MEMORANDUM

FROM: Kaela Champlin, Environmental Program Coordinator, Watershed Protection Department

SUBJECT: Scenic Brook Multifamily Wastewater Service Extension Request #5172

Attachment A

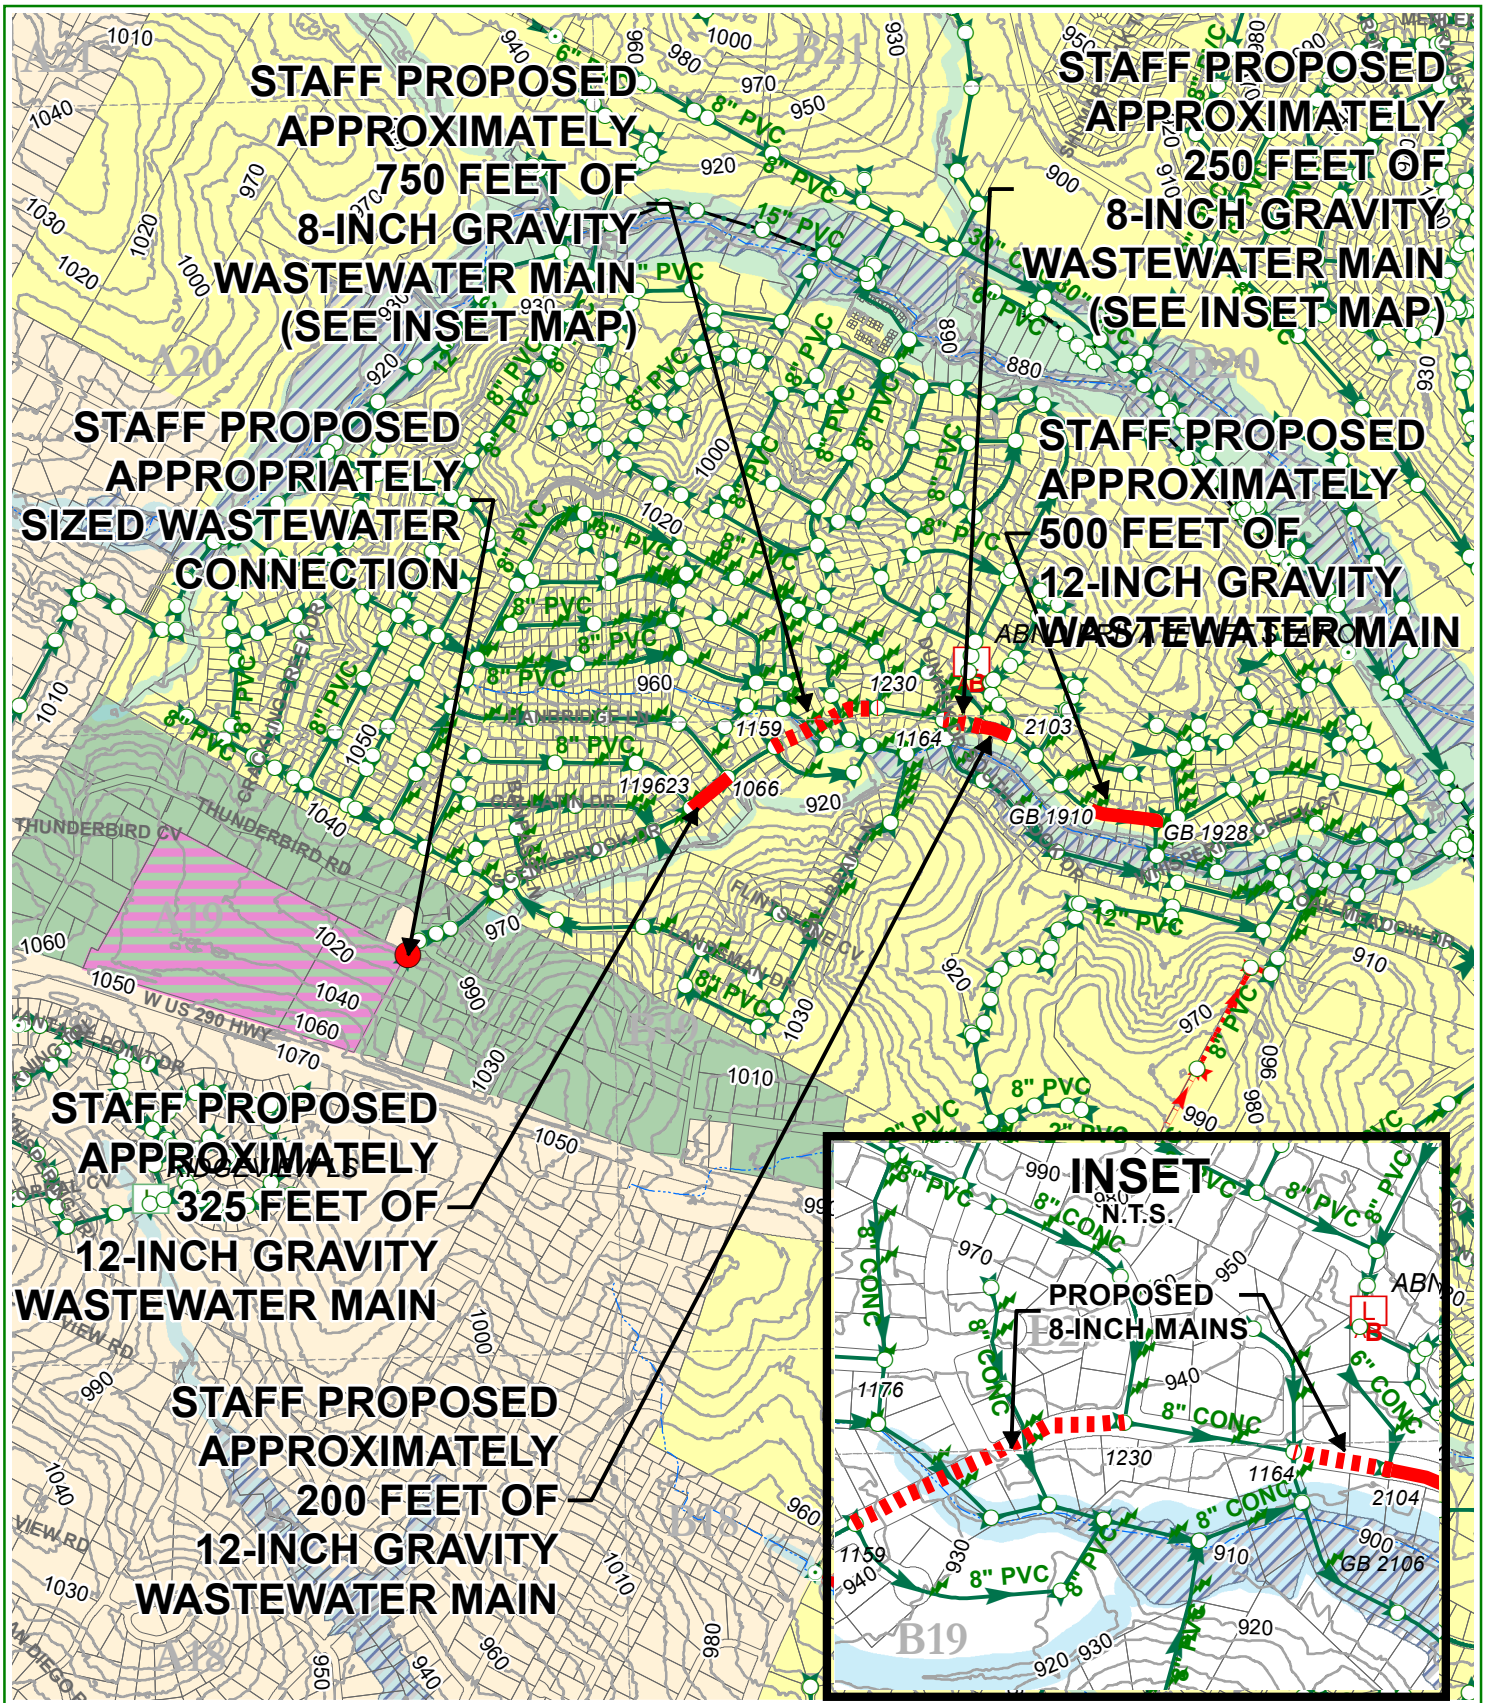
The proposed wastewater infrastructure is described in the following paragraph. A map with the proposed infrastructure can be viewed on Attachment A to this memo.

- Replace 500 feet of 8-inch gravity wastewater main with a 12-inch gravity wastewater main along Scenic Brook Drive from the existing Grade Break #1928 located at 7111 Scenic Brook Drive to the existing Grade Break #1910.

- Replace 200 feet of 8-inch gravity wastewater main with a 12-inch gravity wastewater main along Scenic Brook Drive from the existing manhole (MH) #2103 located in Scenic Brook Drive at Harvest Trail Drive to existing MH #2104.

- Construct 250 feet of 8-inch gravity wastewater main from the proposed 12-inch gravity wastewater main described above in Scenic Brook Drive (located west of the Harvest Trail Drive intersection) and extend west to the existing 8-inch gravity wastewater main (MH #1164) in Scenic Brook Drive at Dunkirk Drive. The applicant will divert wastewater flows currently entering MH #1164 to this proposed 8-inch gravity wastewater main.

- Construct 750 feet of 8-inch gravity wastewater main from the existing 8-inch gravity wastewater main (MH #1230) located in Scenic Brook at Red Will Drive and extend southwest along Scenic Brook Drive to the existing 8-inch gravity wastewater main (MH #1159) in Scenic Brook Drive at Kirkham Drive. The applicant will divert wastewater flows currently entering MH #1159 to this proposed 8-inch gravity wastewater main.

- Replace 325 feet of 8-inch gravity wastewater main with a 12-inch gravity wastewater main along Scenic Brook Drive from the existing MH #1066 located in Scenic Brook Drive at Hanbridge Lane to MH #119623.

The proposed wastewater line will require a Land Use Commission variance because a portion of the line is located within and parallel to the Water Quality Transition Zone for Williamson Creek. The wastewater line would align with Scenic Brook Drive and be built underneath the footprint of the existing road. A Land Use Commission variance will be processed with the site plan associated with the wastewater line.

WPD staff recommends Wastewater SER #5172 for the following reasons:

- There are no significant environmental concerns to extend service to the property.
- Due to the proposed density of the development and the unsuitability of the soils onsite, centralized wastewater service is environmentally preferable to decentralized service.
